## Darden Clean Energy Project (23-OPT-02)

### CEC Data Request Response Set #3

**Figure 1 Emergency Backup Generator Modeling Locations**

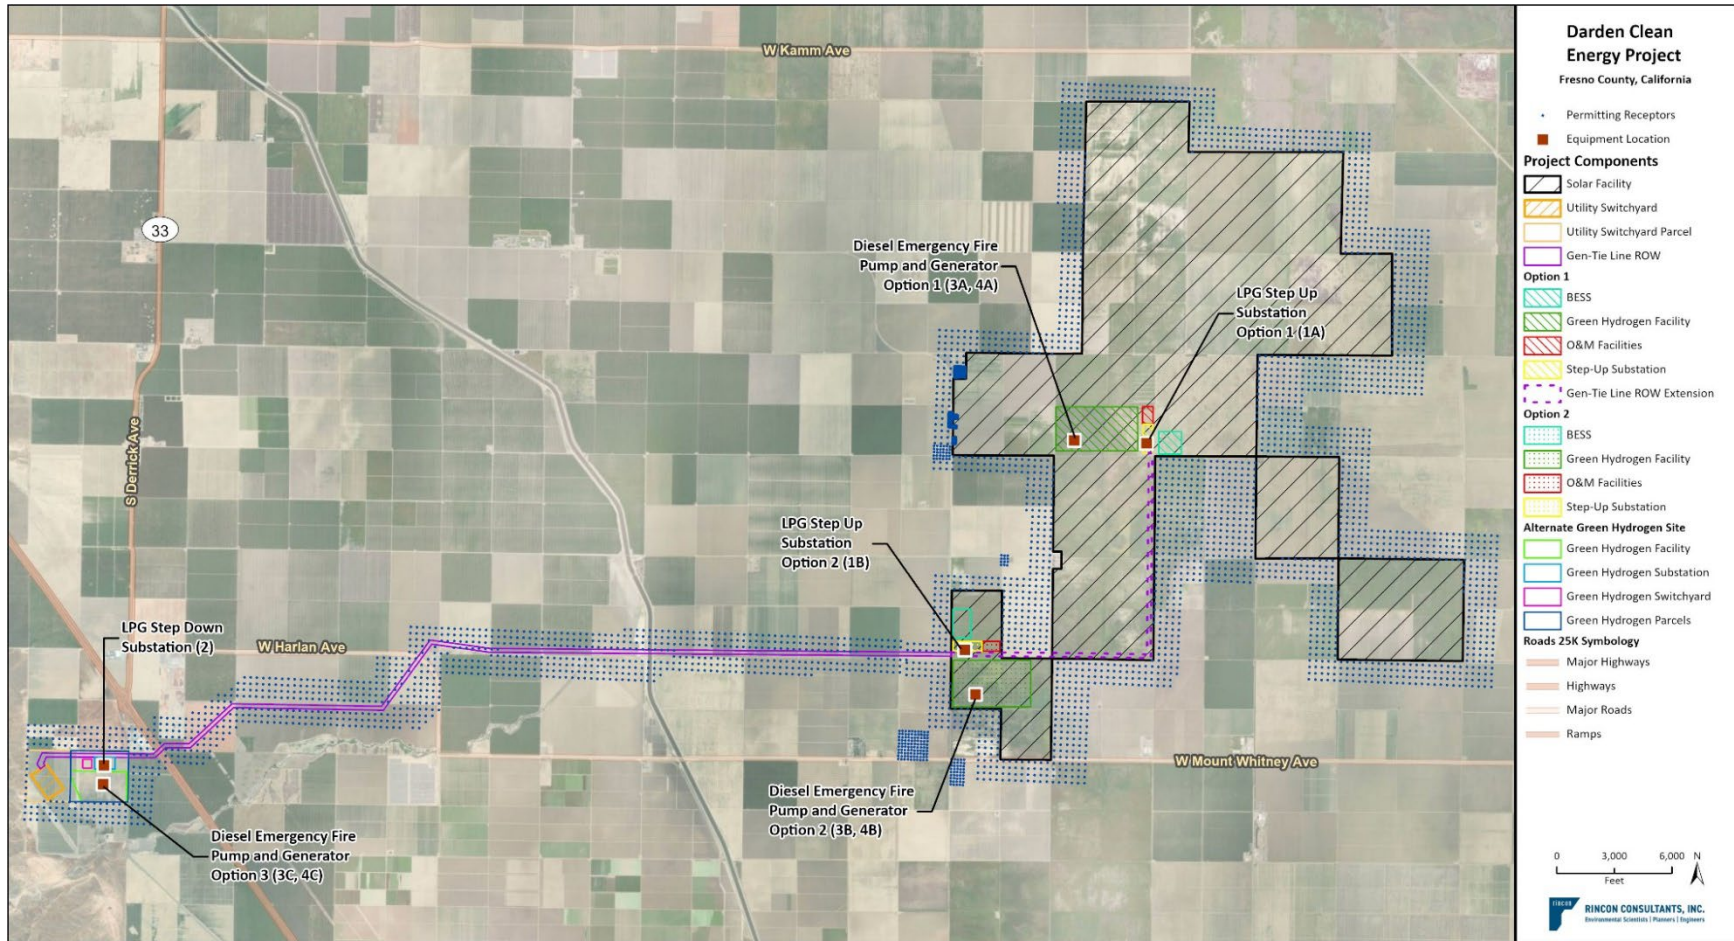
**DR AQ-12:** Please provide the proposed locations of all backup generators and provide the modeling results for readiness testing and maintenance at each location by treating them as point sources instead of multiplying their emissions by the area source results.

**DR PH-5:** Please provide the proposed point source locations of all backup generators and provide the modeling results of diesel PM from readiness testing and maintenance operations by treating the stationary sources as point sources at each of the proposed locations.

**Response:** Specific locations for each backup generator will be finalized in later stages of engineering and design. Prospective locations of all backup generators for each of the potential Project design scenarios (i.e., Option 1, Option 2, and Alternate Green Hydrogen Site) are depicted in Figure 1. The equipment was assumed to be centrally located in each project area (i.e. near the center of each proposed Green Hydrogen site), as it was determined that the equipment would be unlikely to be located near project and/or fenceline boundaries. There are multiple pieces of diesel equipment expected for each of the potential hydrogen facility design scenarios; however, as specific individual locations are not yet known, all units for each Project design scenario were collocated at a single point for the purposes of air dispersion modeling. Point source air dispersion modeling for readiness testing and maintenance was conducted at each location. The results of the modeling are provided in Appendix C of Appendix A.

**Response:** The proposed locations of all backup generators for each of the potential Project design scenarios are described in the response to DR AQ-12 and depicted in Figure 1. Point source air dispersion modeling for readiness testing and maintenance was conducted at each location. The results of the modeling are provided in Appendix C to Appendix A.
